<p>CLAYTON COUNTY Water AUTHORITY</p> <p>1600 Battle Creek Road, Morrow, GA 30260</p>	Jesters Creek East Outfall Replacement – Phase 2	
	ADDENDUM #1	
	DATE	Wednesday, December 29, 2021
	BID NUMBER	2021-PME-22
	BID OPENING DATE	January 6, 2022, at 2:00 pm
ADDENDUM MUST BE SIGNED AND INCLUDED IN YOUR RESPONSE TO THE RFB.

**JESTERS CREEK EAST OUTFALL
REPLACEMENT – PHASE 2**

CONSTRUCTION PLAN FOR JESTERS CREEK EAST OUTFALL REPLACEMENT PHASE TWO FOR BID

DESIGN BY:	CCWA	DATE:	10-28-21
DRAWN BY:	JRM	JOB #:	81914
CHECKED BY:		DRAWING #:	P-7
		SCALE:	1" = 50'
		SHEET NUMBER	11 OF 23

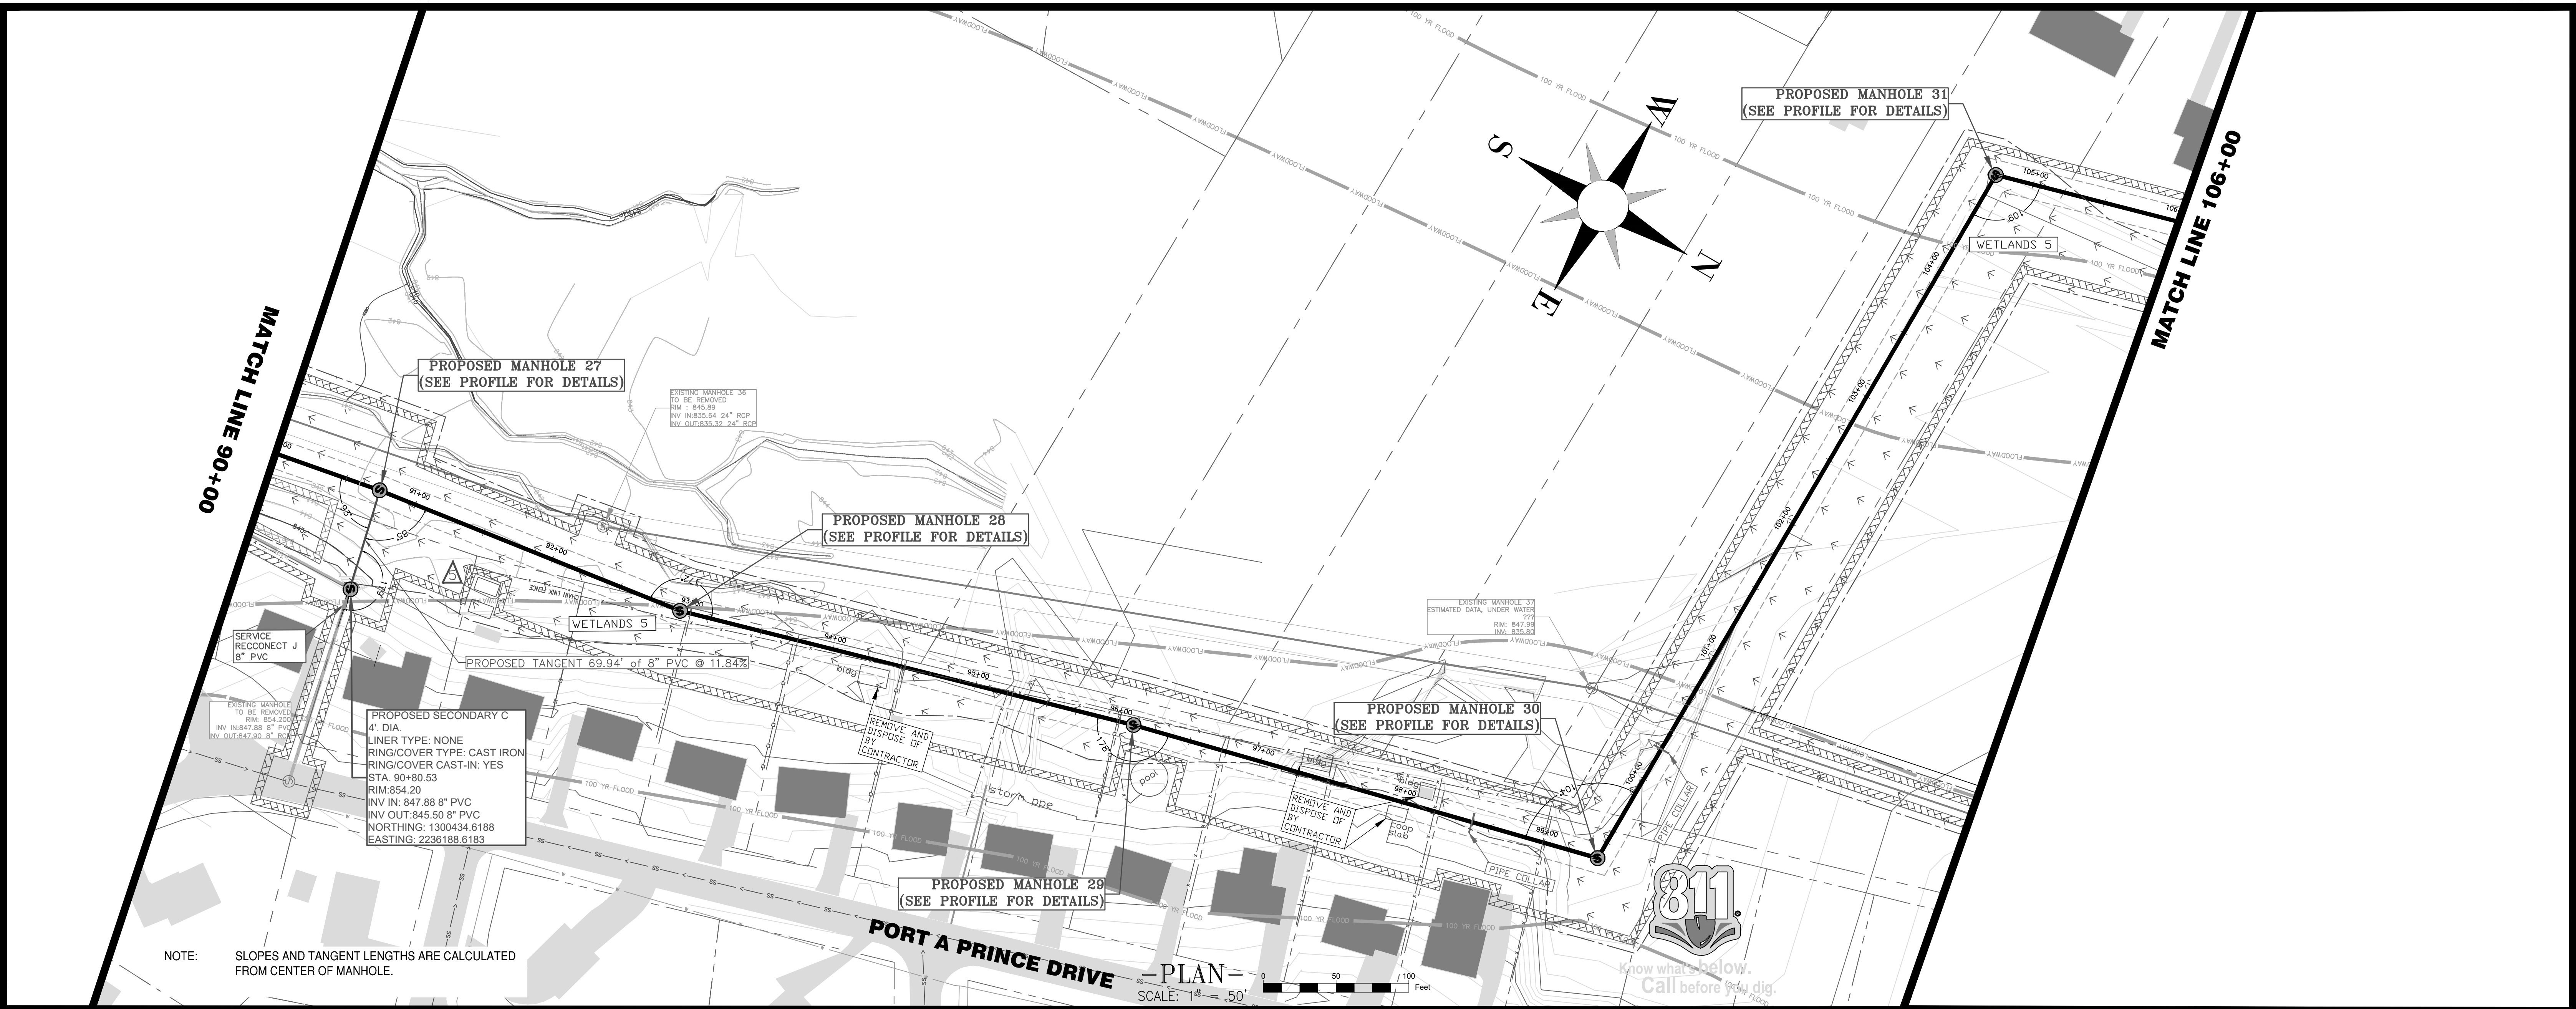
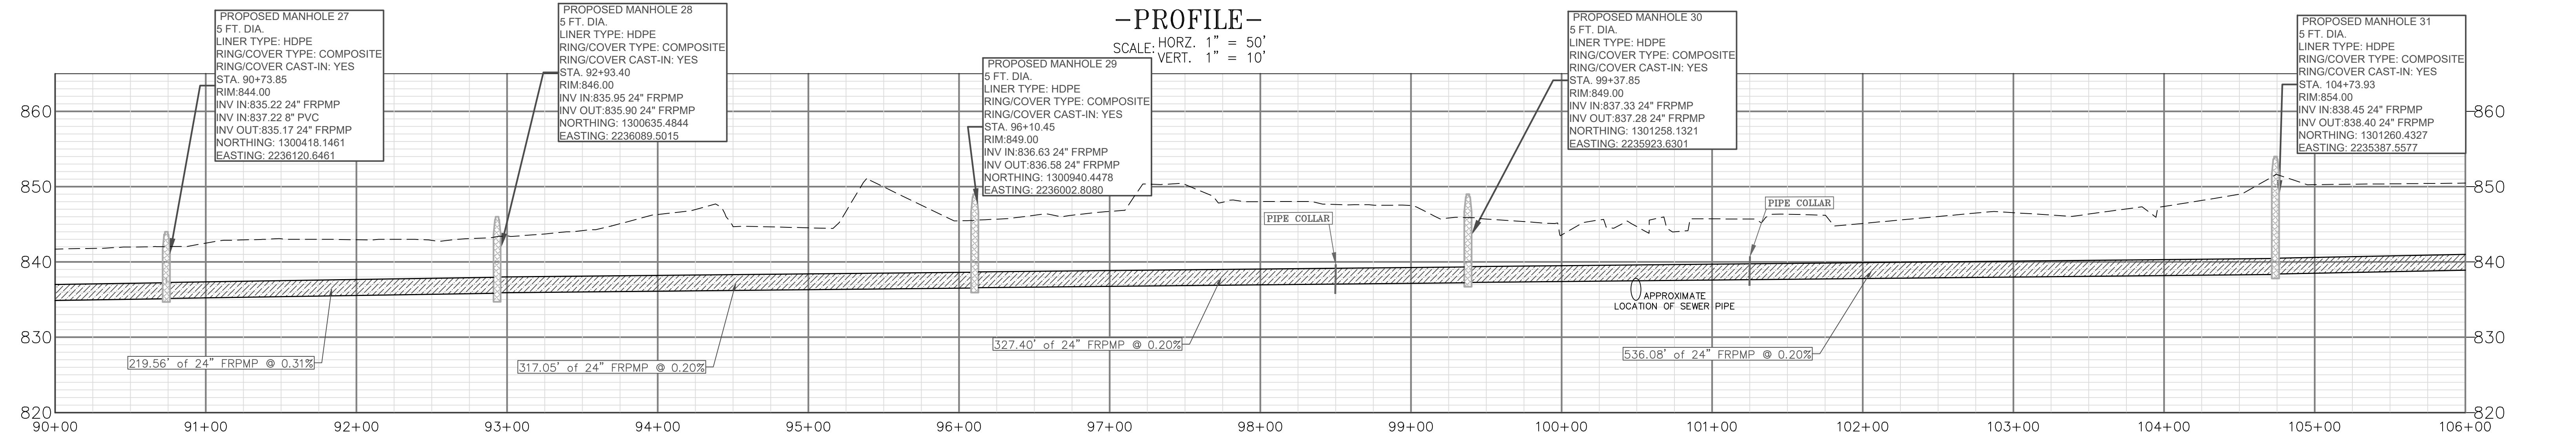
- 19. Drawing #P-7, Is contractor to remove and dispose of portable building near STA 91+60?**

The building near station 91+60 is to remain.

DATE:	NO.:	REQUESTED BY:	DESCRIPTION:
12-20-21	1	KW	WETLANDS 1 THROUGH 6 REVISED
12-20-21	2	KW	ALL 24" PIPE TO BE FRPMP
12-20-21	5	KW	REVISED CONSTRUCTION LIMITS

DESIGN BY:	CCWA	DATE:	10-28-21
DRAWN BY:	JRM	JOB #:	81914
CHECKED BY:		DRAWING #:	P-8
		SCALE:	1" = 50'
		SHEET NUMBER	12 OF 23

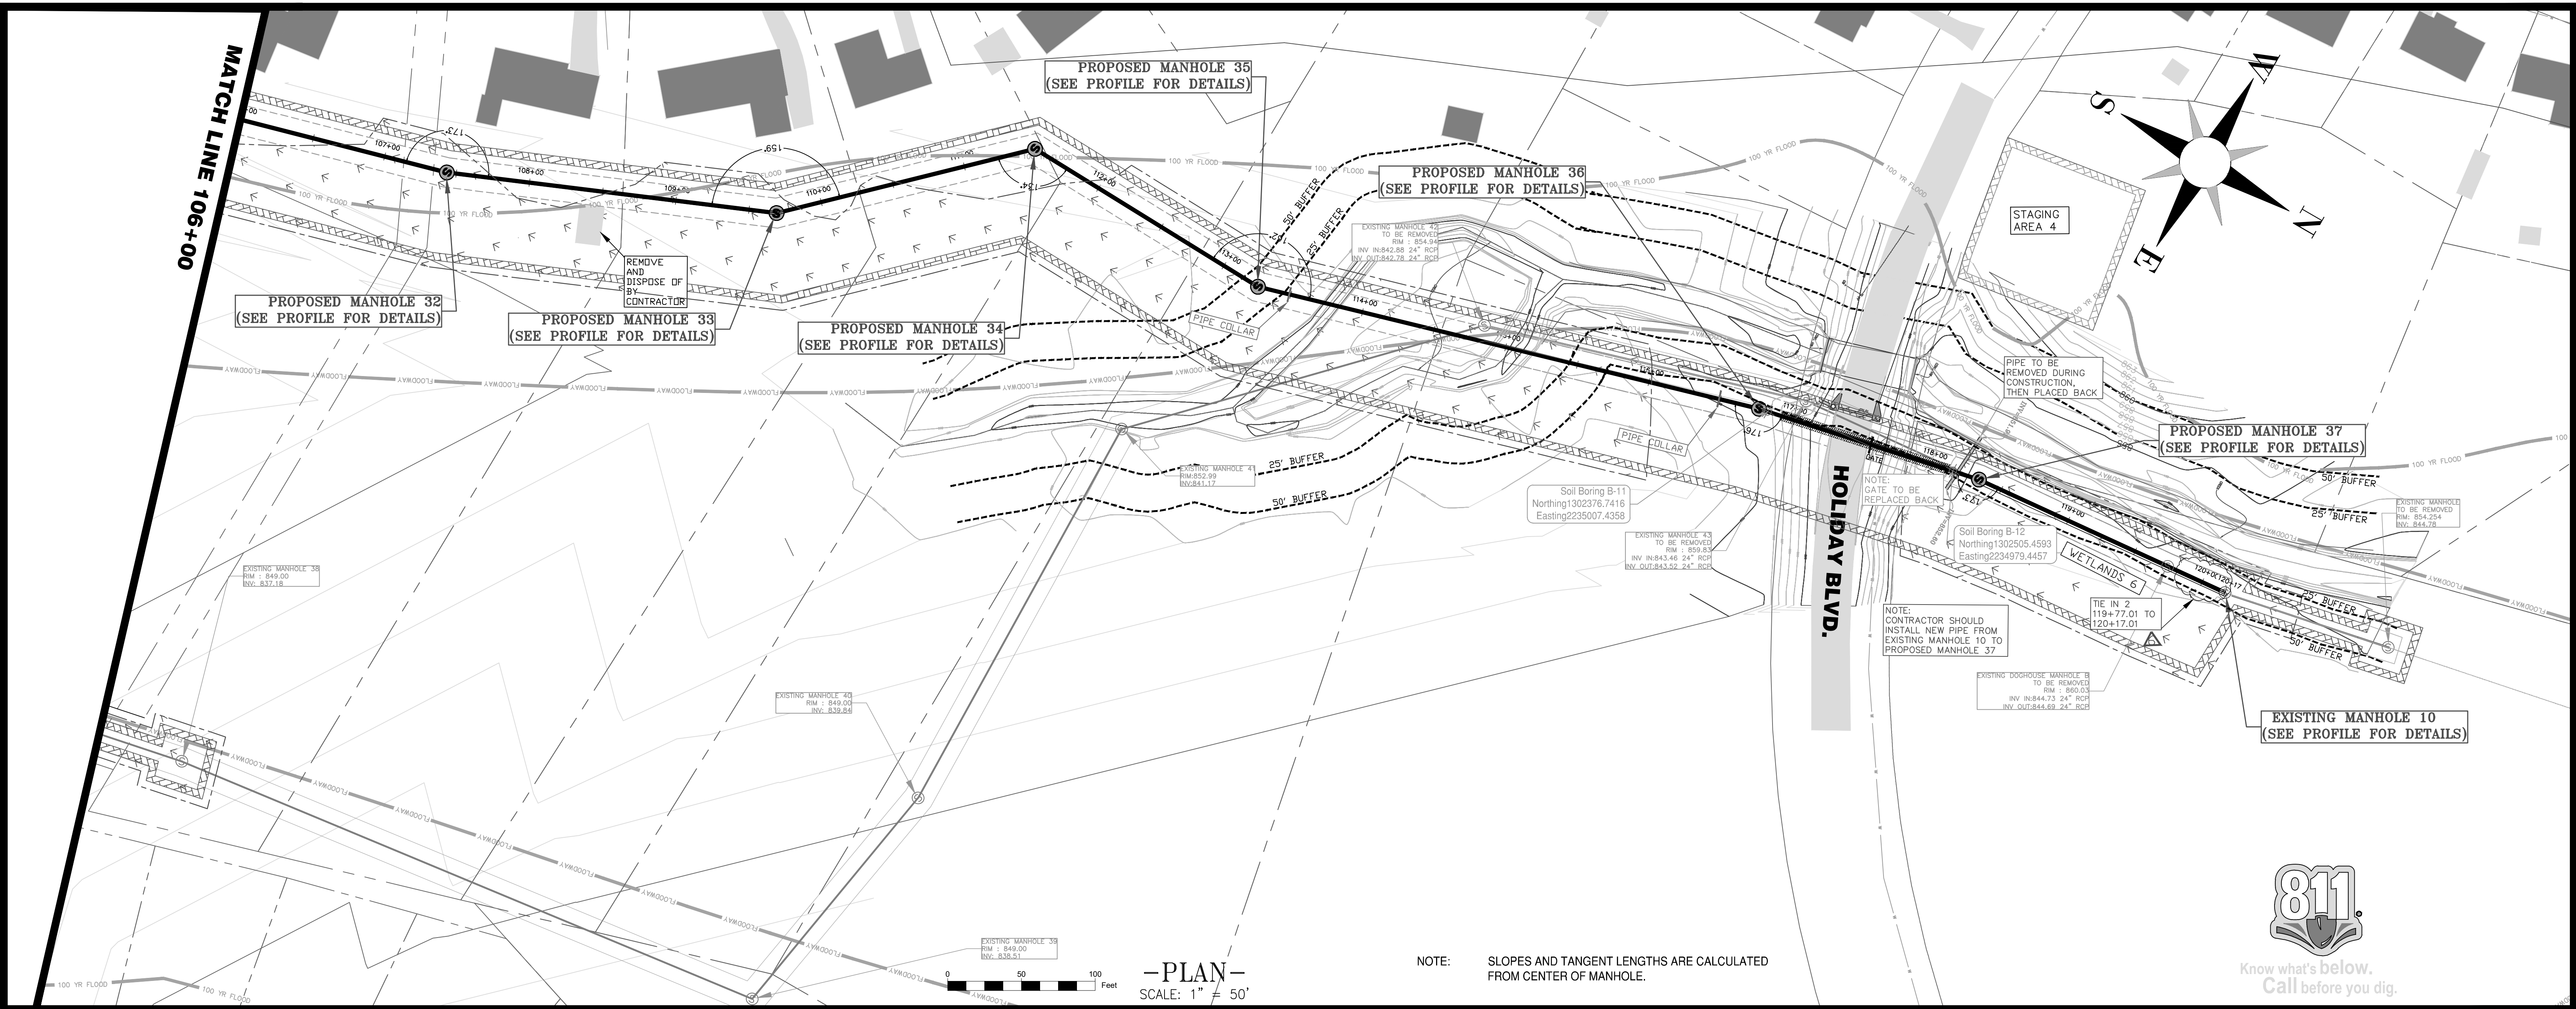
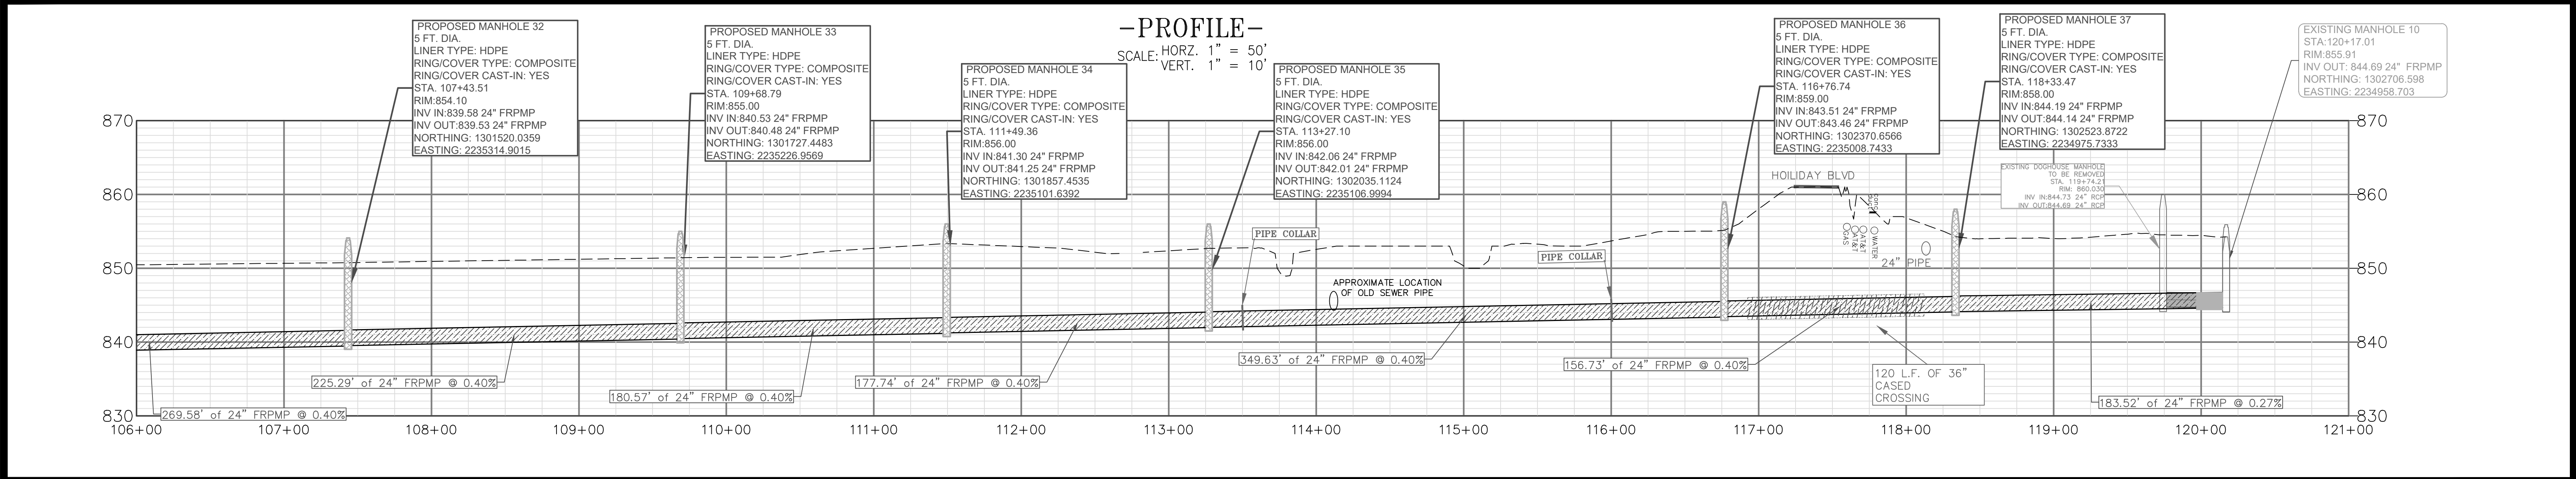
16. Specifications Page 4-1.6, Work Items 20-21 indicates primary pipe from survey station 0+40 (end of Tie-In No. 1) to survey station 65+42 (beginning of Tie-In No. 2). Work Item 17 indicates that Tie-In No. 2 begins at survey station 119+64.24. Please clarify.

- 17. There are multiple references of STA 65+42 (beginning of Tie-In No. 2) in Work Assignment and Measurement for Payment. Please clarify.**

The beginning of Tie-In No. 2 is at survey station 119+77.01. Work Items 17, 20 – 21 and 25-31 have been revised to indicate the correct station.

DATE:	NO.:	REQUESTED BY:	DESCRIPTION:
12-20-21	1	KW	WETLANDS 1 THROUGH 6 REVISED
12-20-21	2	KW	ALL 24" PIPE TO BE FRPMP
12-20-21	6	KW	TIE IN NUMBER 2 LABEL

CASED CROSSING
N.T.S.

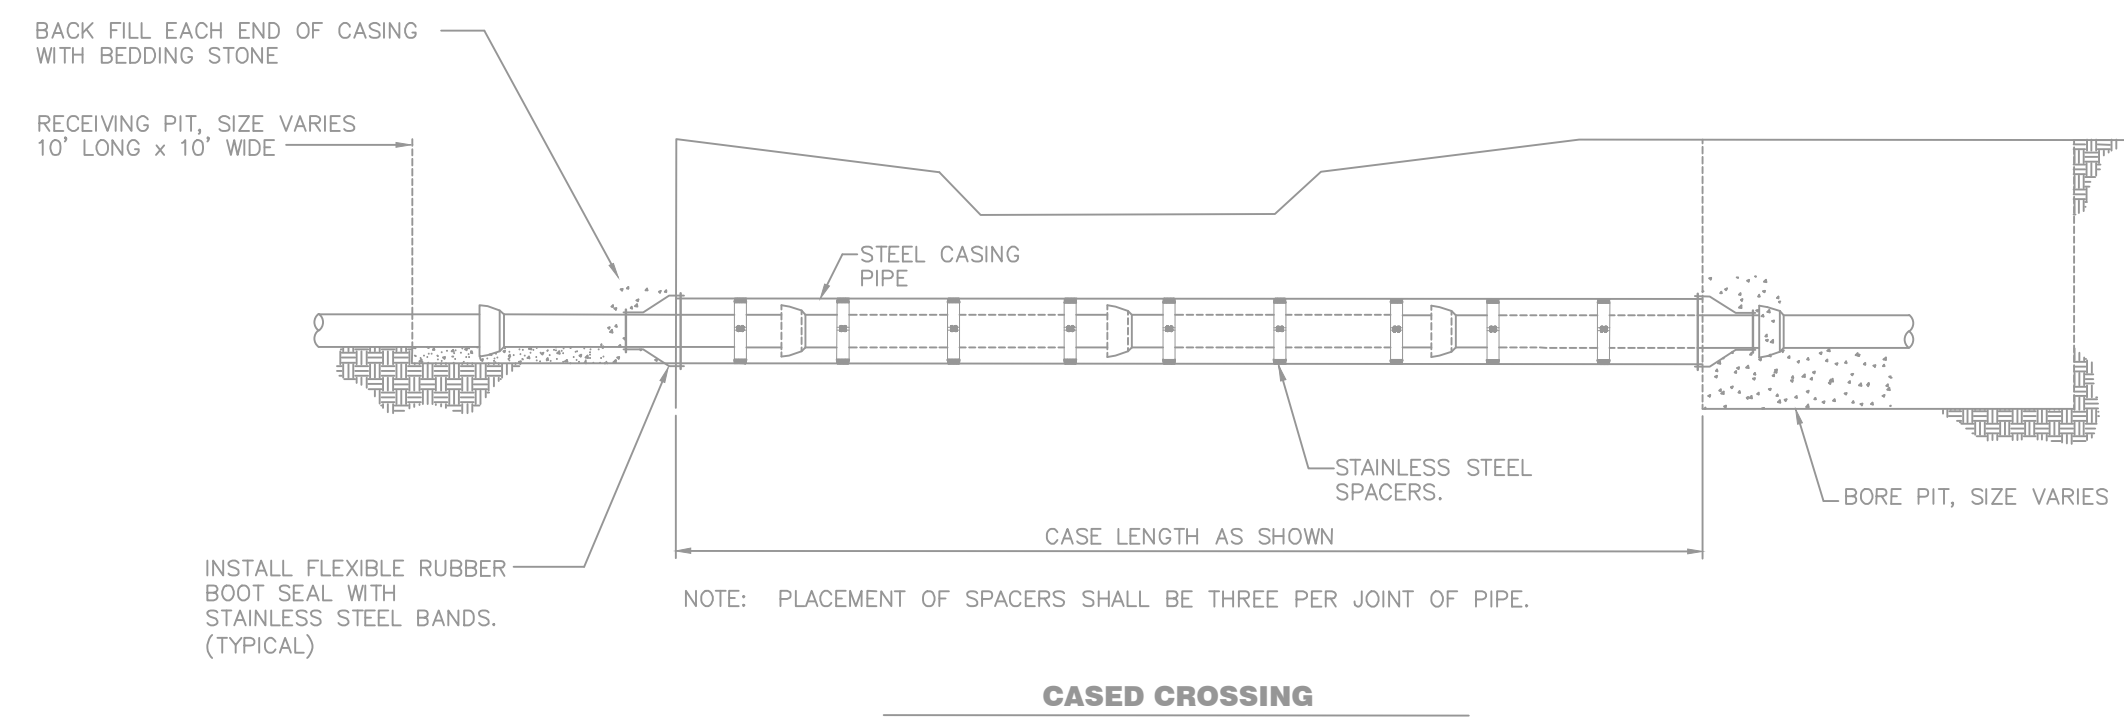
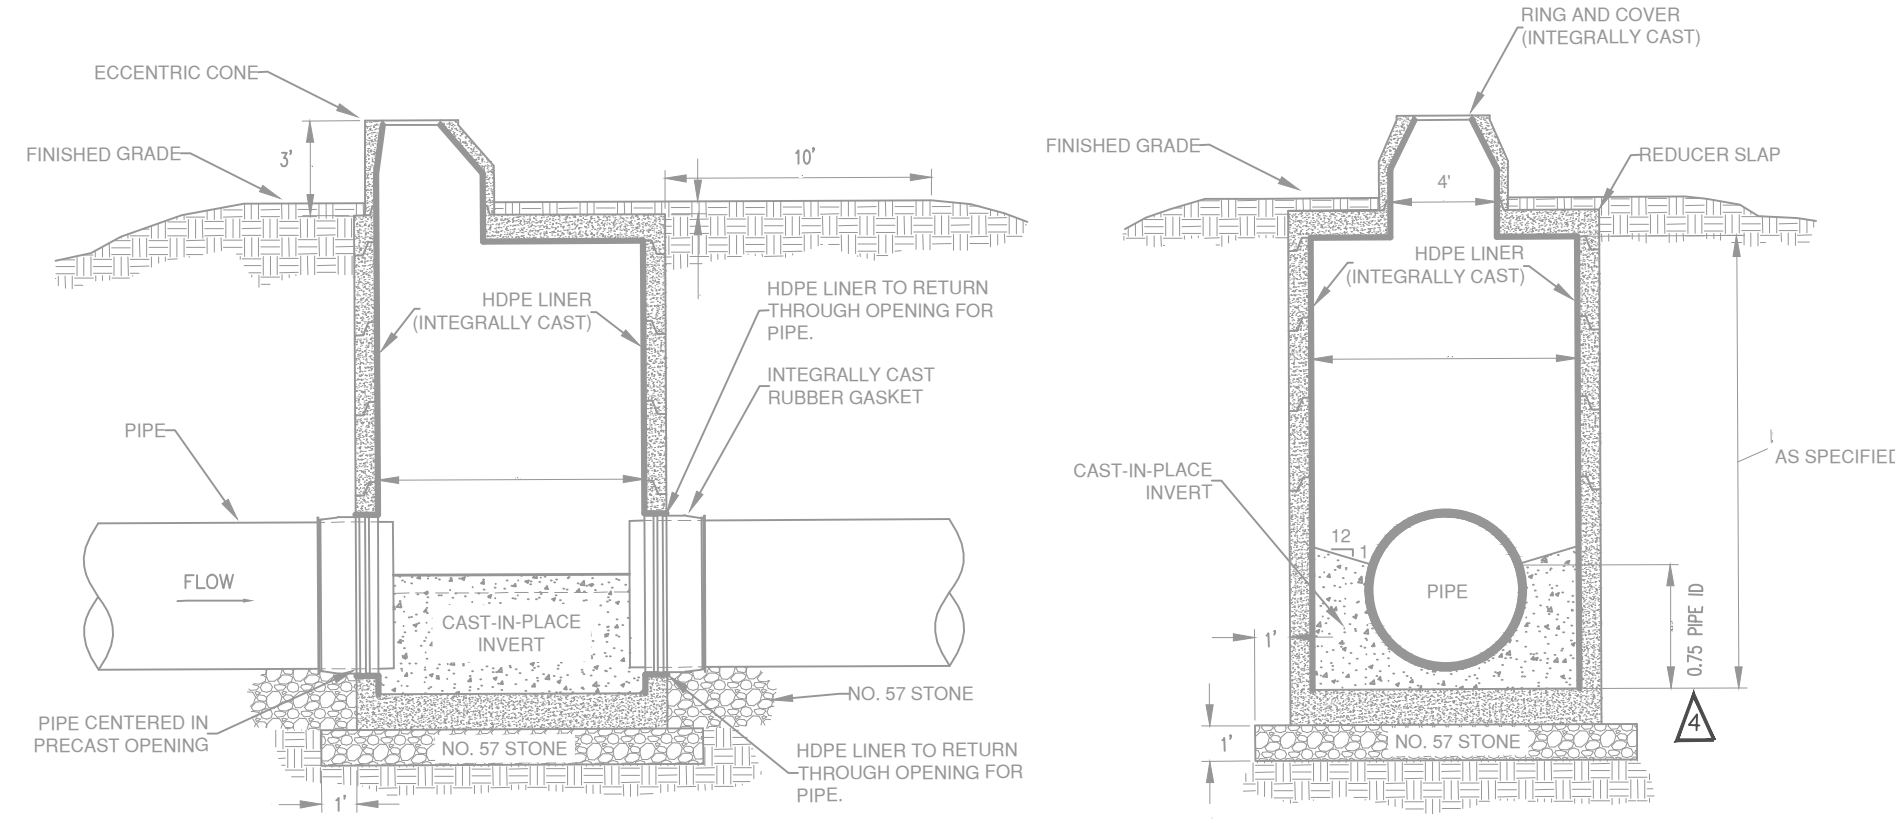
- 3. Cased Crossing No. 1 calls out 36” casing for a 24” gravity carrier pipe. This may need to be upsized to accommodate grade on the carrier pipe. If CCWA is providing casing, will they provide the upsized casing?**

Casing size, as indicated on the Drawings, will be installed by the Contractor.
